Amendment

/16 NO.1 TRITON SQUARE

246868-A_A-XX-03-DR-AX-31003 Level 03 Floor Plan

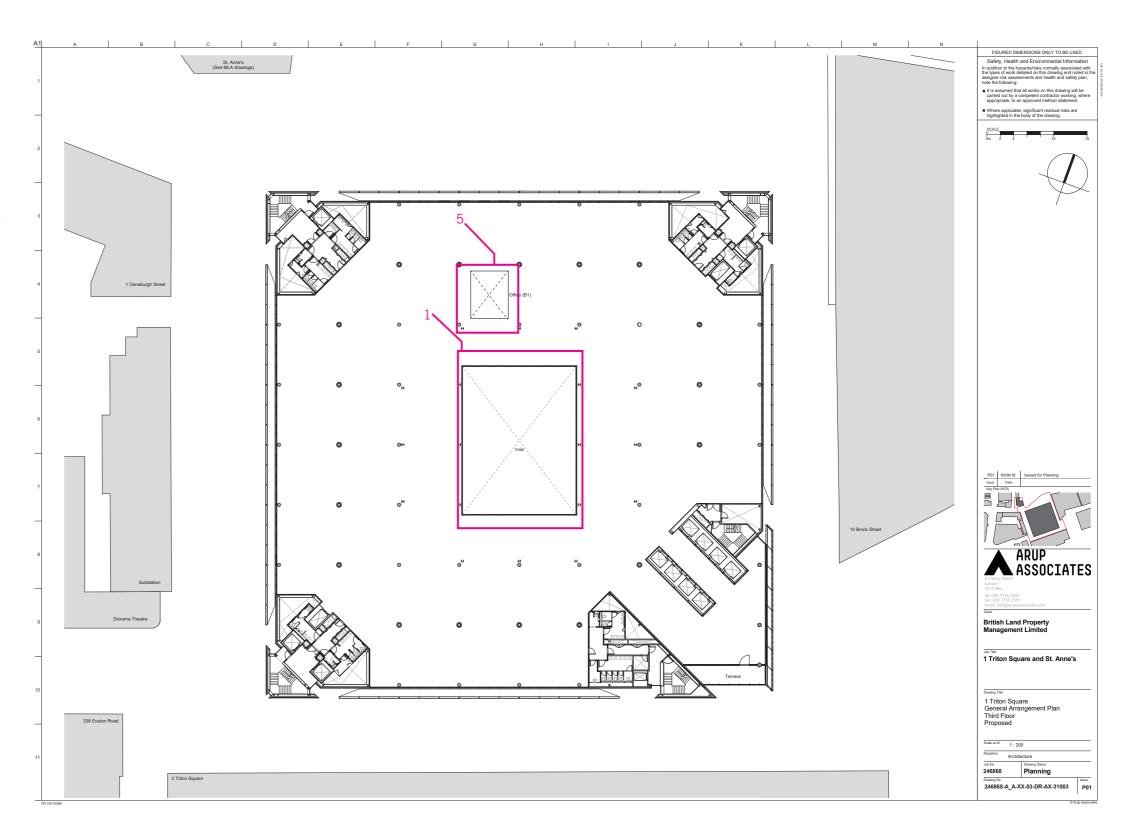
- (1) The incoming tenant has asked for a change to the atrium profile from vertically aligned balustrades to a profile that steps in and out. This shift is to the north and south sides of the atrium only.
- (5) Slab opening formed at Level 02, 03, 04 to accommodate internal stairs to be incorporated as part of tenant fit-out works.

246868-A_A-XX-04-DR-AX-31004 Level 04 Floor Plan

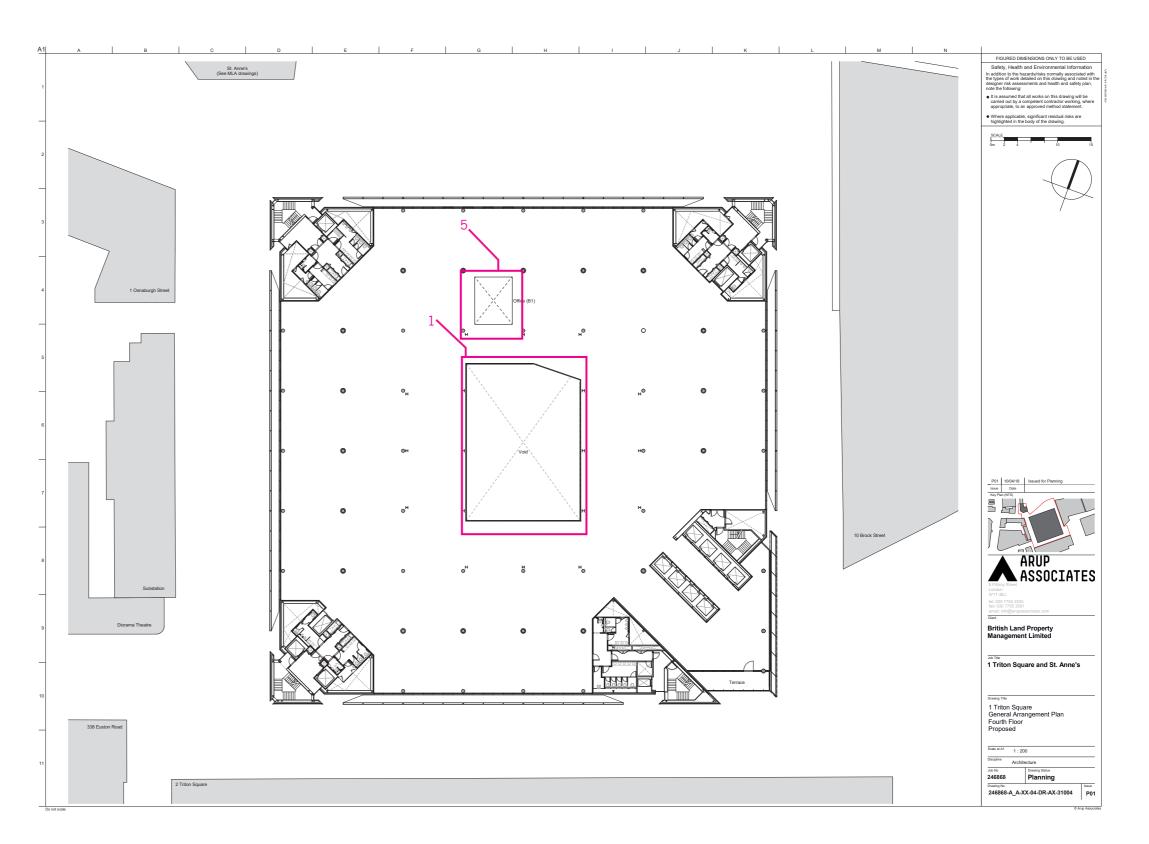
- (1) The incoming tenant has asked for a change to the atrium profile from vertically aligned balustrades to a profile that steps in and out. This shift is to the north and south sides of the atrium only.
- (5) Slab opening formed at Level 02, 03, 04 to accommodate internal stairs to be incorporated as part of tenant fit-out works.

246868-A_A-XX-06-DR-AX-30080 Level 06 Floor Plan

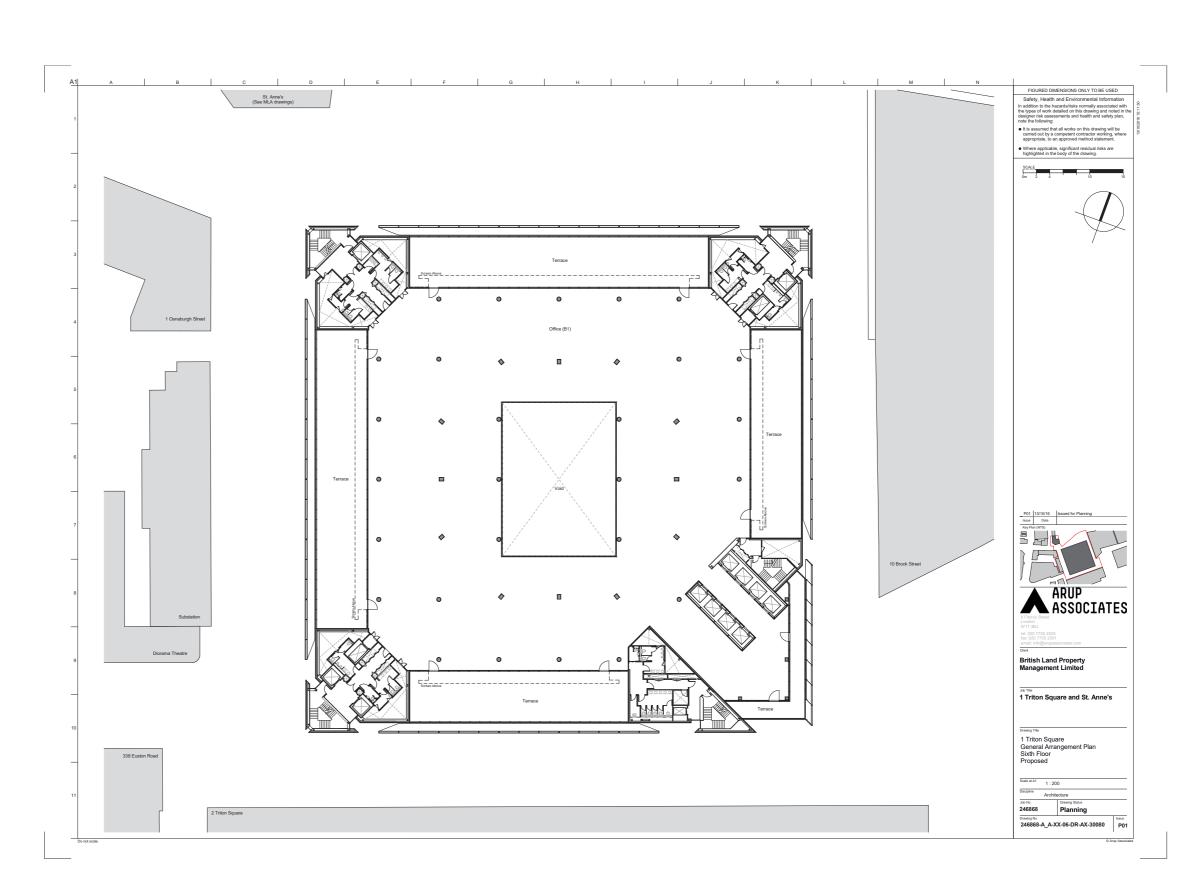
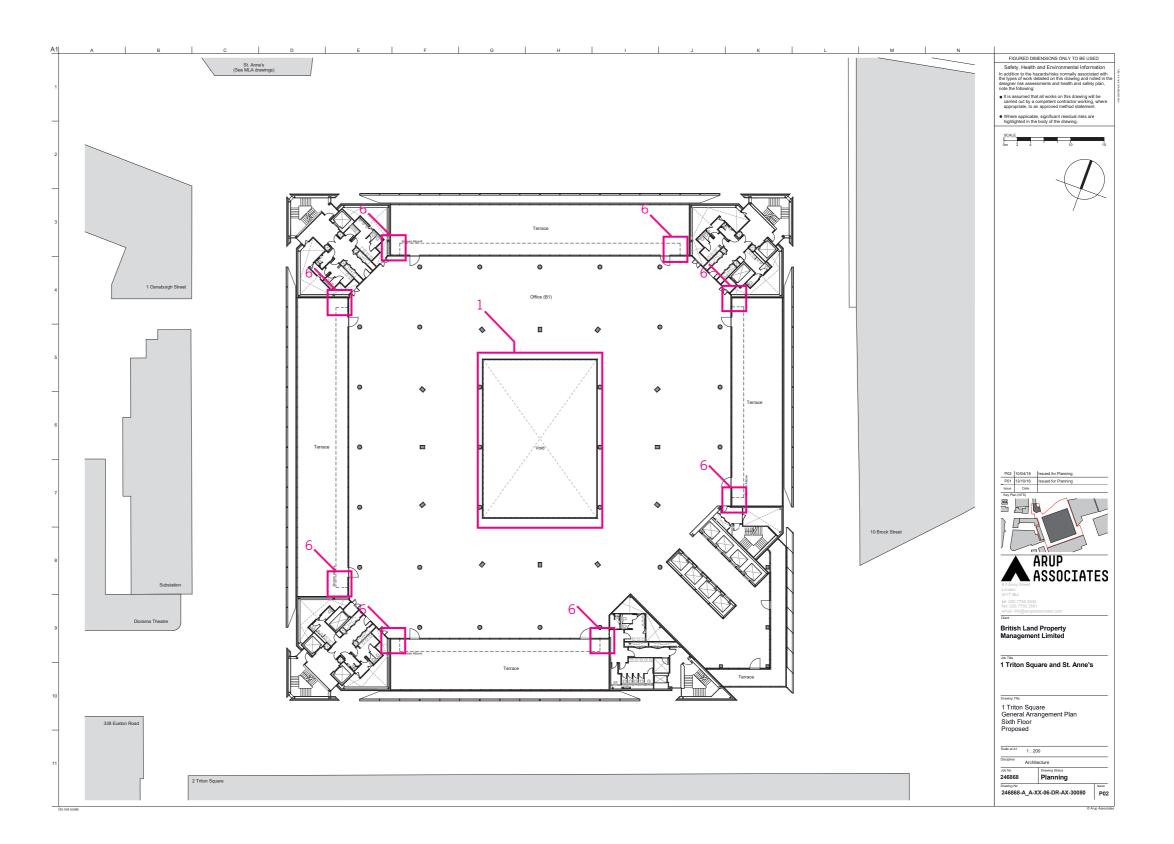
- (1) The incoming tenant has asked for a change to the atrium profile from vertically aligned balustrades to a profile that steps in and out. This shift is to the north and south sides of the atrium only.
- (6) As part of facace technical development, upper screens simplified and floorplate infilled behind. Overall increase of 48m² GIA.

246868-A_A-XX-07-DR-AX-31007 Level 07 Floor Plan

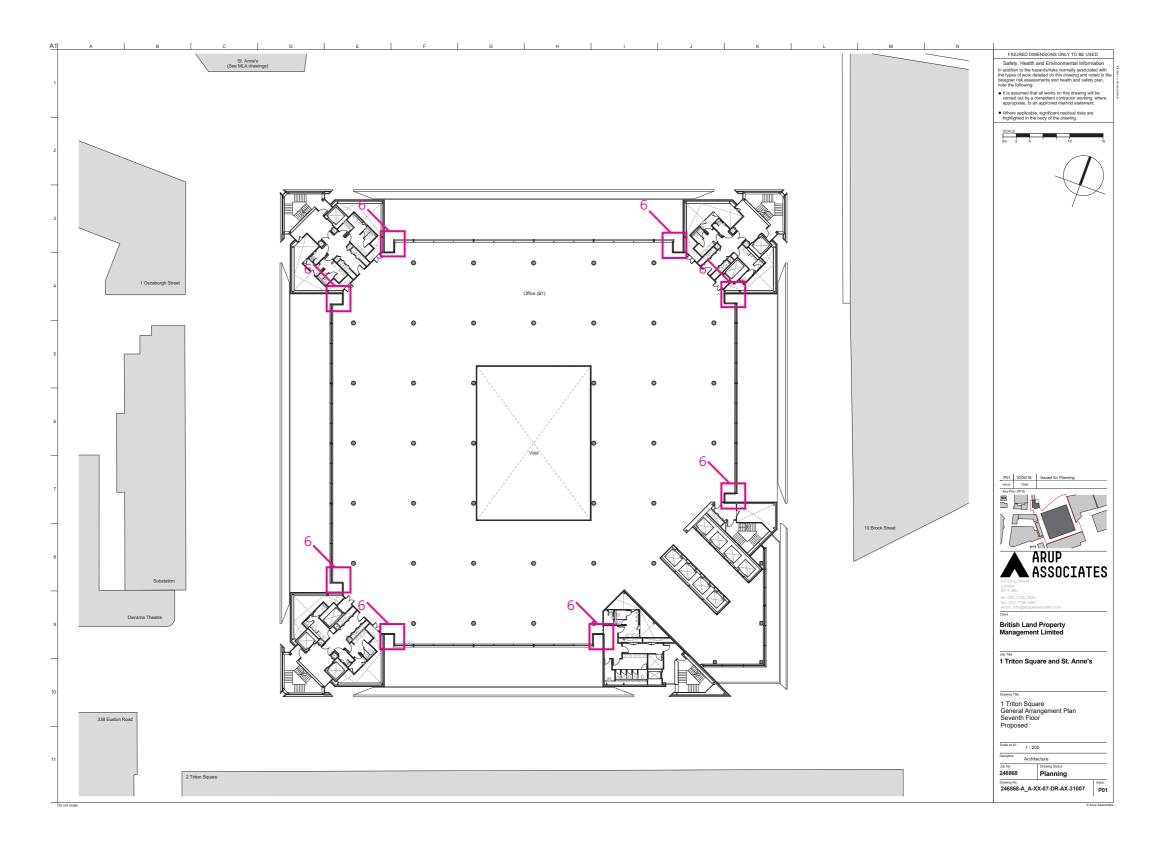
(6) As part of facace technical development, upper screens simplified and floorplate infilled behind. Overall increase of 48m² GIA.

246868-A_A-XX-08-DR-AX-31008 Level 08 Floor Plan

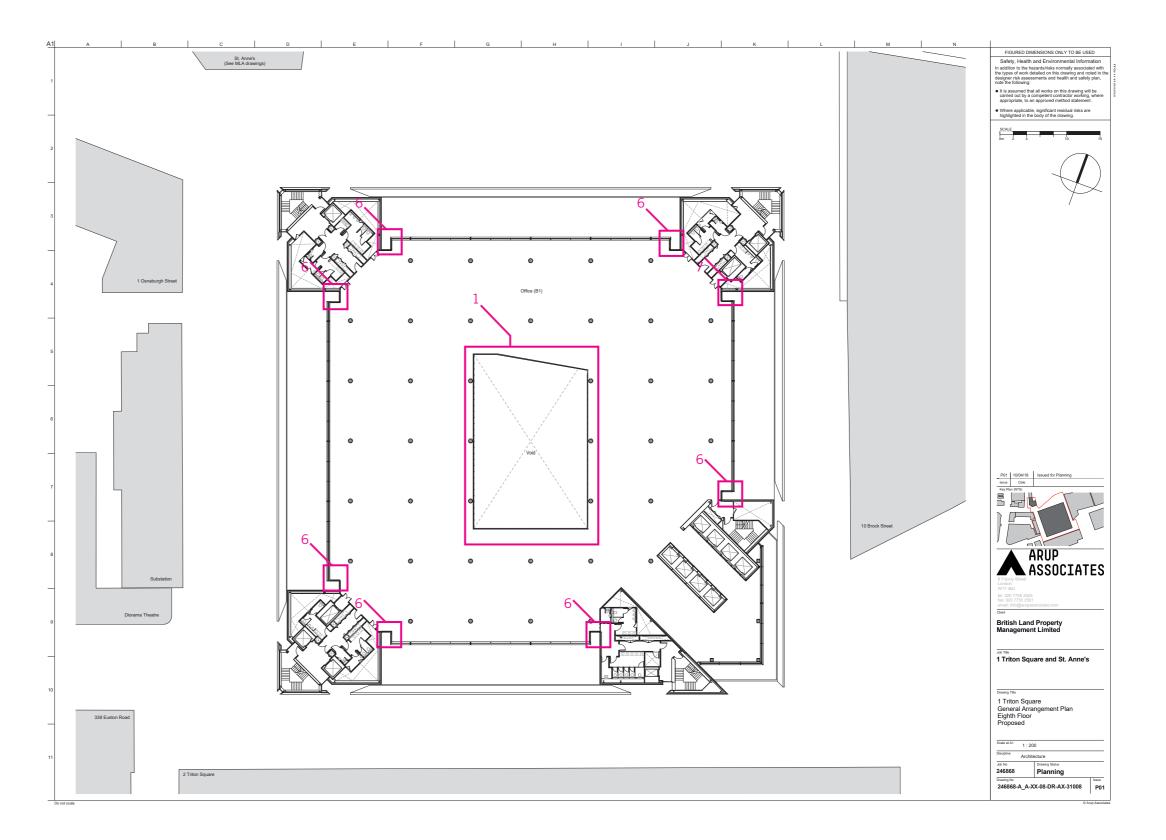
- (1) The incoming tenant has asked for a change to the atrium profile from vertically aligned balustrades to a profile that steps in and out. This shift is to the north and south sides of the atrium only.
- (6) As part of facace technical development, upper screens simplified and floorplate infilled behind. Overall increase of 48m² GIA.

246868-A_A-XX-09-DR-AX-30110 Level 09 Plan

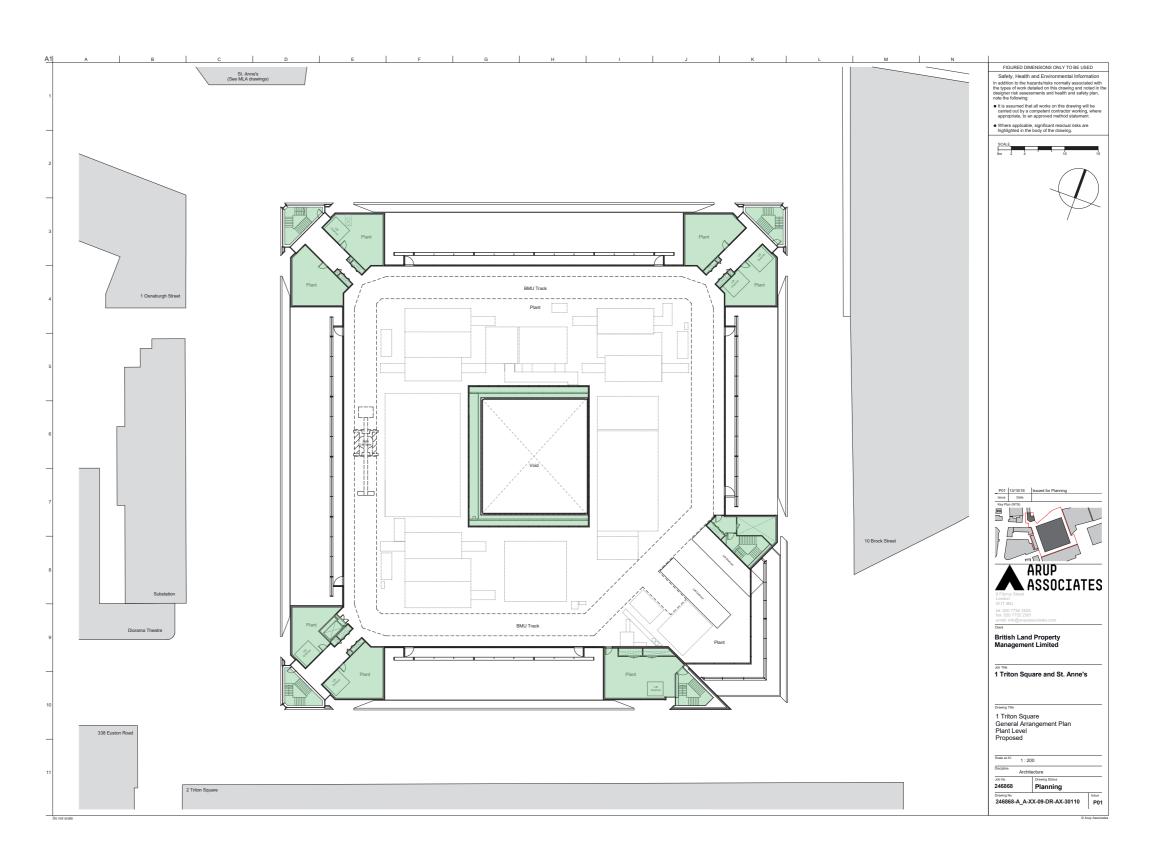
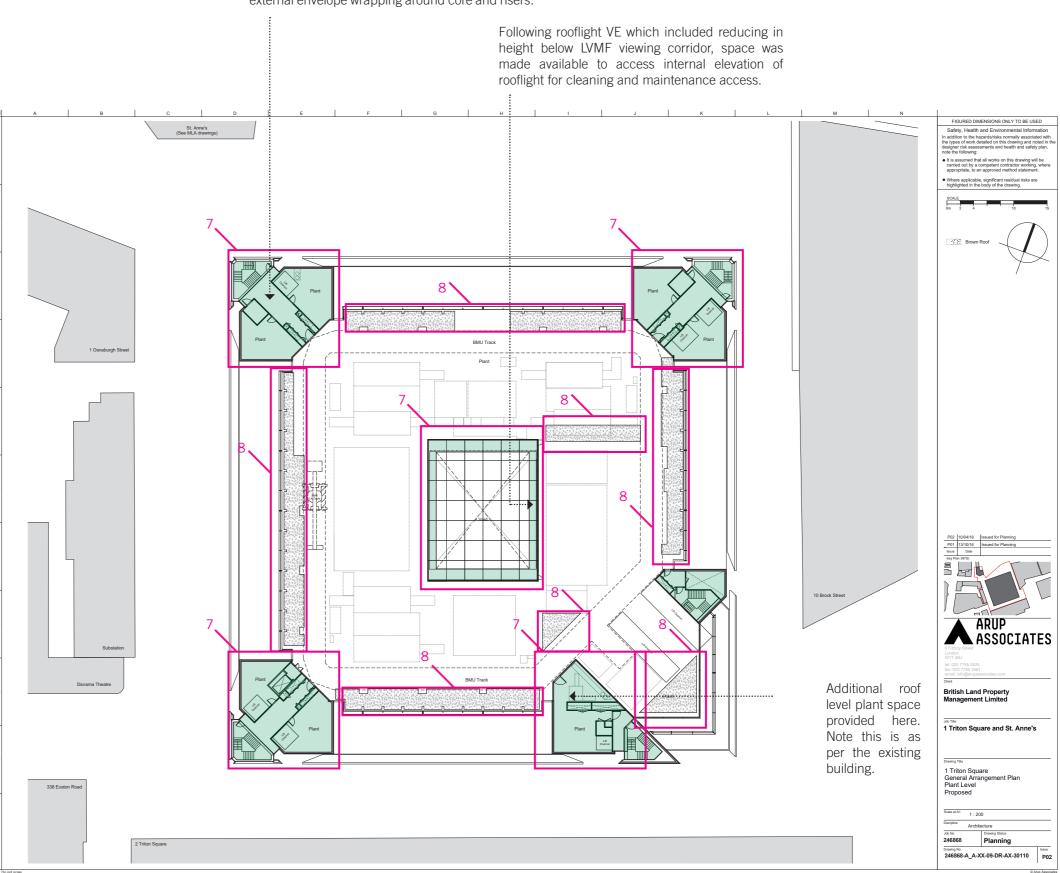
Access corridor made internal to reduce length of external envelope wrapping around core and risers.

- (7) Access to plant level at top of cores covered to become internal space. Addition of 219m² GIA.
- (8) Access to brown roof at top of cores for maintenance via mansafe system was deemed problamatic from a health and safety perspective. Therefore the brown roofs have been relocated from top of cores Level 10 to Level 09 roof.

246868-A_A-XX-10-DR-AX-30120 Level 10 Plan

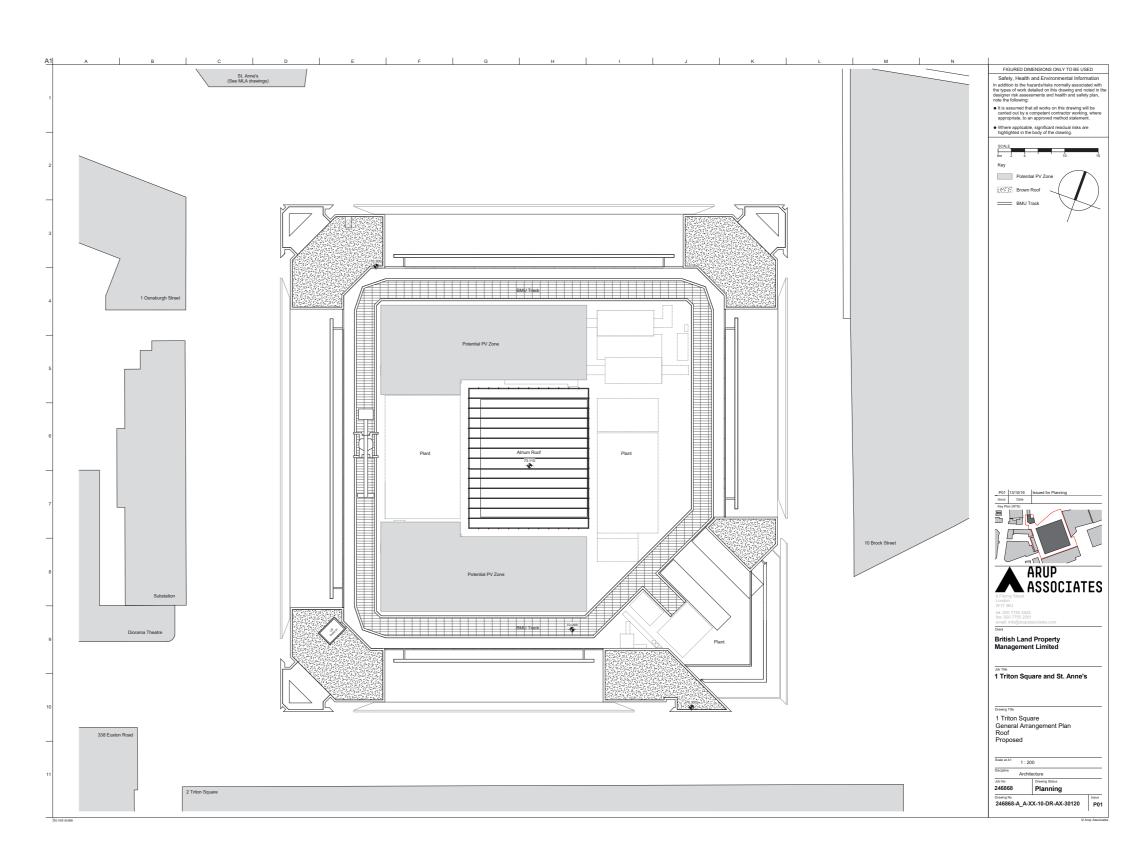
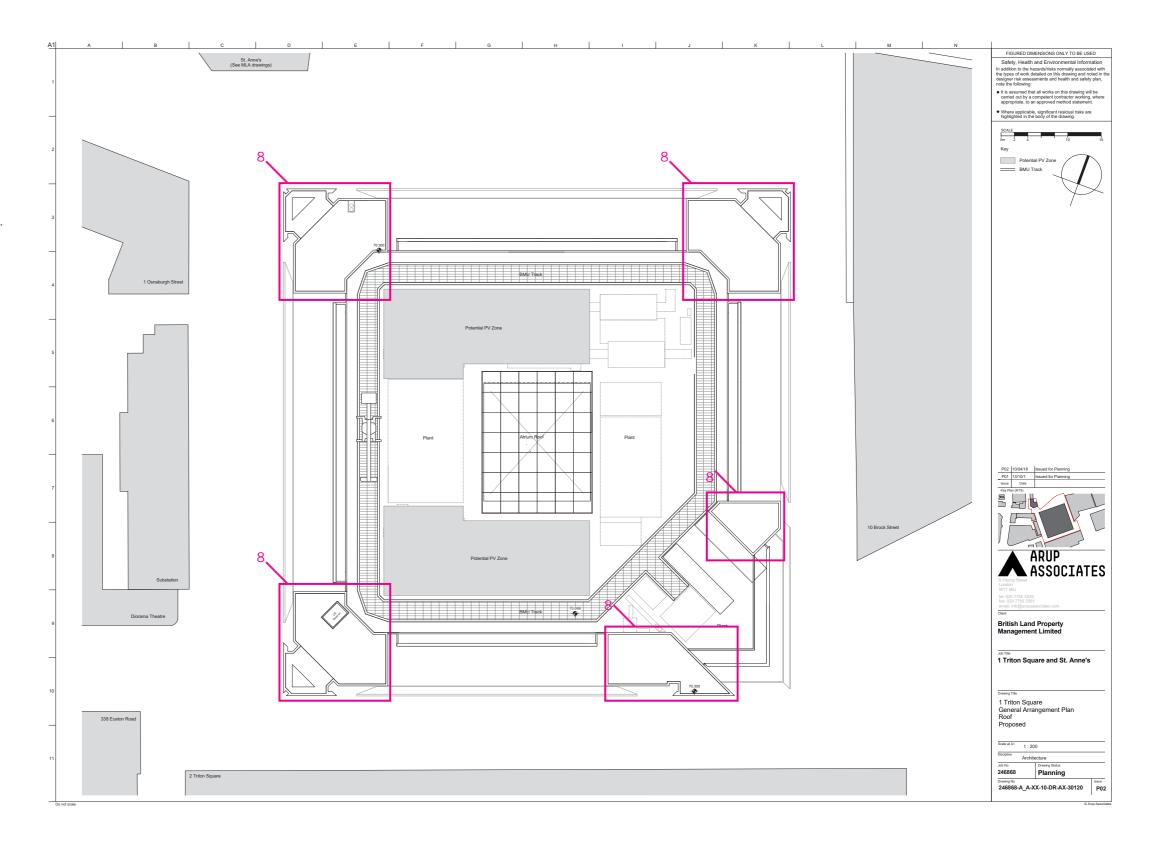
(8) Access to brown roof at top of cores for maintenance via mansafe system was deemed problamatic from a health and safety perspective. Therefore the brown roofs have been relocated from top of cores Level 10 to Level 09 roof.
